CITY OF WESTFIELD, IN
Advisory Planning Commission Meeting Agenda_06_20_2016

1606-DDP-21

Urban Vines

Request: Detailed Development Plan approval for a vineyard and winery building on 5 acres +/-, and associated waivers.

1 North (Front) Elevation
Scale: 1/4" = 1'-0"

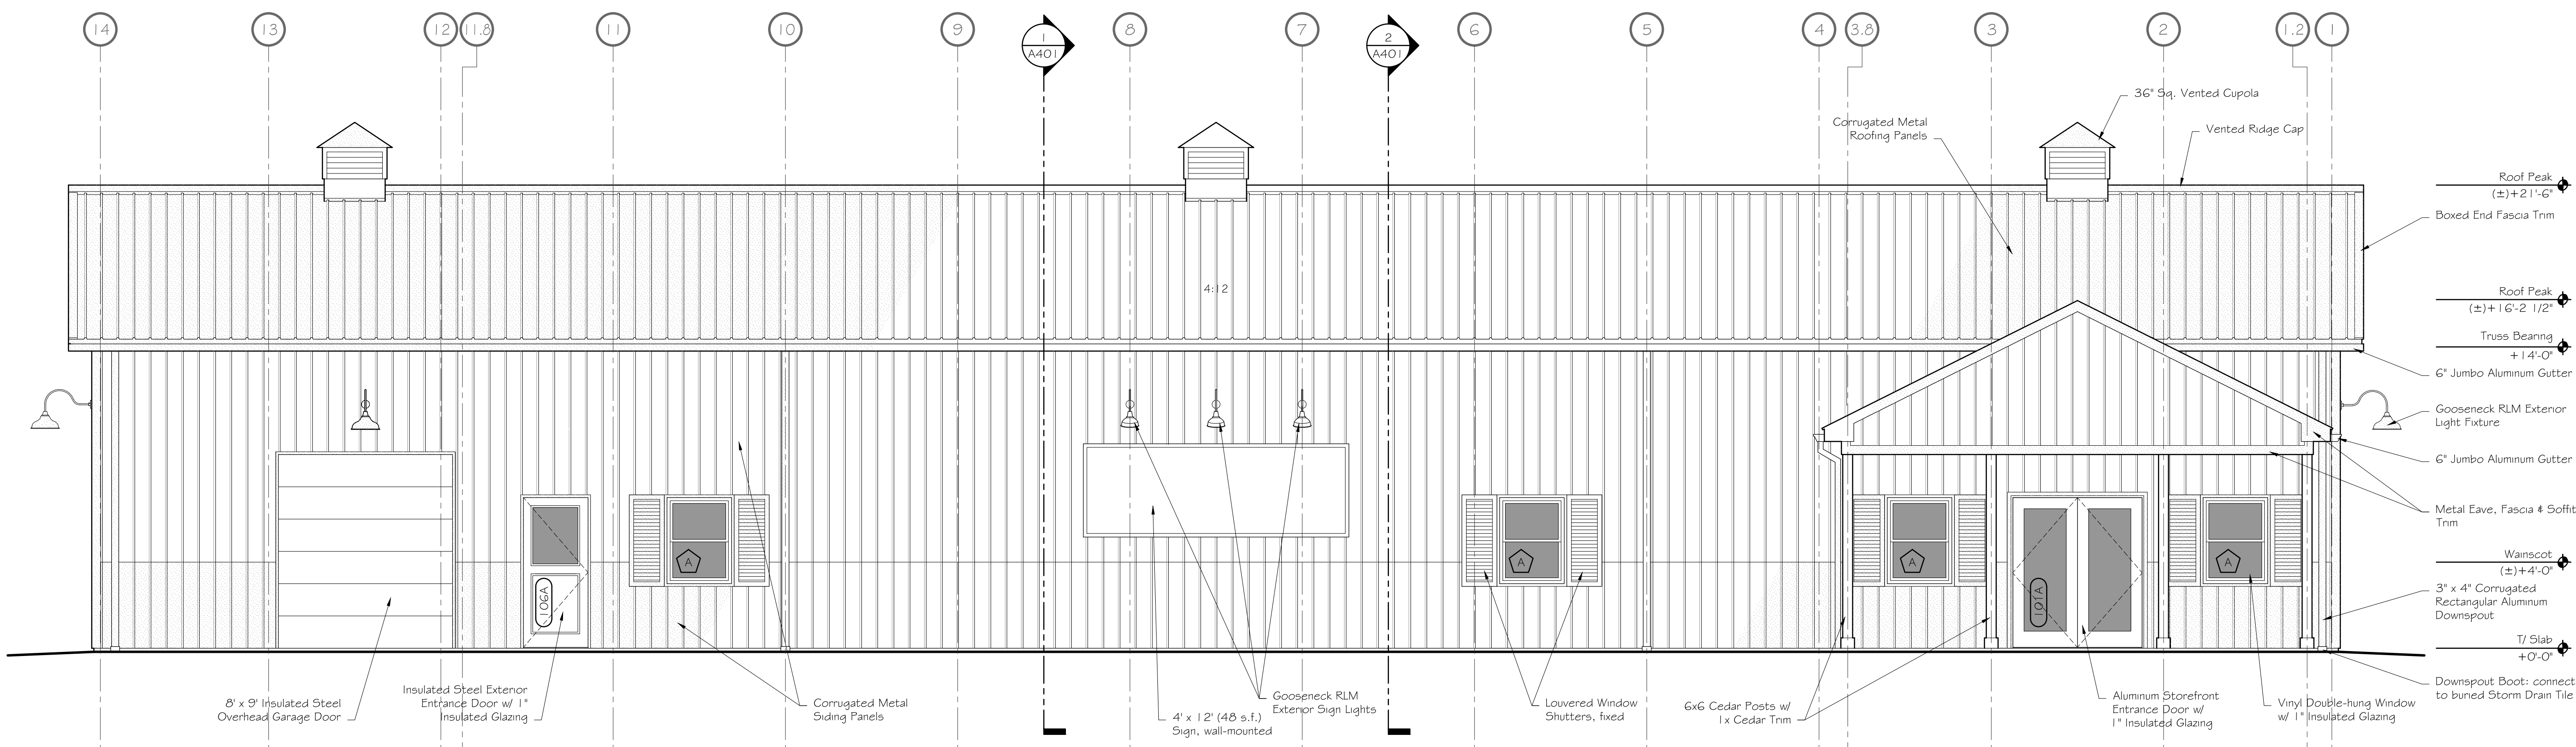
Comment: Does not apply pursuant to 1604-VS-07; however, the condition of approval requires buildings to exceed or be substantially similar in quality and character to the Illustrative Character Exhibit. Since the public hearing, the petitioner has revised the proposed building's design, as depicted in Exhibit 4, to address the comments from the public hearing.
